PINEHURST - A, B, C

LAFAYETTE MEADOWS LOT 13
272 LONG MEADOW LANE
FUQUAY VARINA, NC 27526
PIN#0653-29-2798.000

ProjectName: Lafayette Meadows Lot 13	Project #: 0528.T0145
Project Location: Fuquay-Varina, NC	Summit Representative: Juan Espina, EI
Date: June 30, 2021	Permit Number: N/A
Client/Contractor: DR Horton	Trips: 0
Work Performed: Plan Issue	Structural Project Manager

SUMMIT was contacted on June 29, 2021 by Brandon Cox to address the required framing for a side entry garage for the house to be built on Lot 13 of the Lafayette Meadows community. The structural plans (ref. 0528.T0083) that were used during this evaluation were prepared by SUMMIT and sealed by Brian C. Philbrick, Jr, PE on May 28,2021. Below is a summary of our findings:

FIGURE 1: PARTIAL CRAWLSPACE FOUNDATION

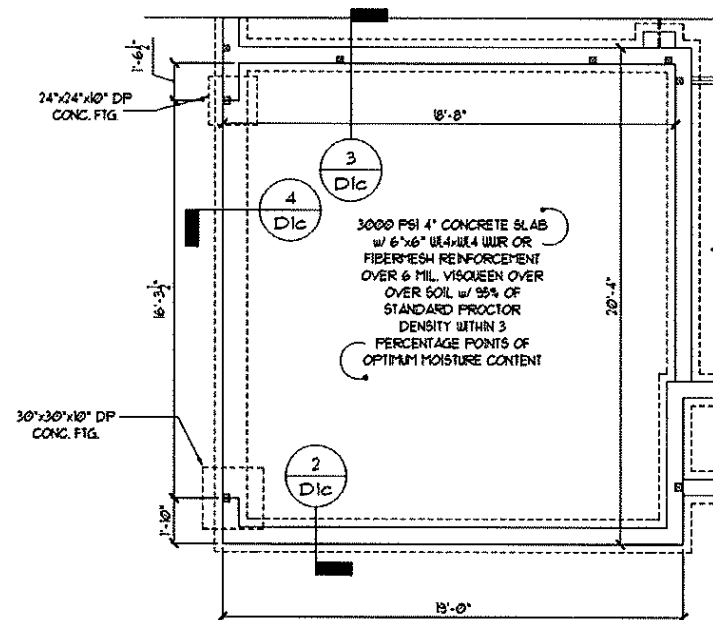
Based on plan review and analysis, please refer to figured 1 and 2 of this report for the required framing for a side entry garage. No other framing and/or foundation members have been analyzed at this time and shall be constructed in accordance with the set of sealed structural drawings permitted for this lot.
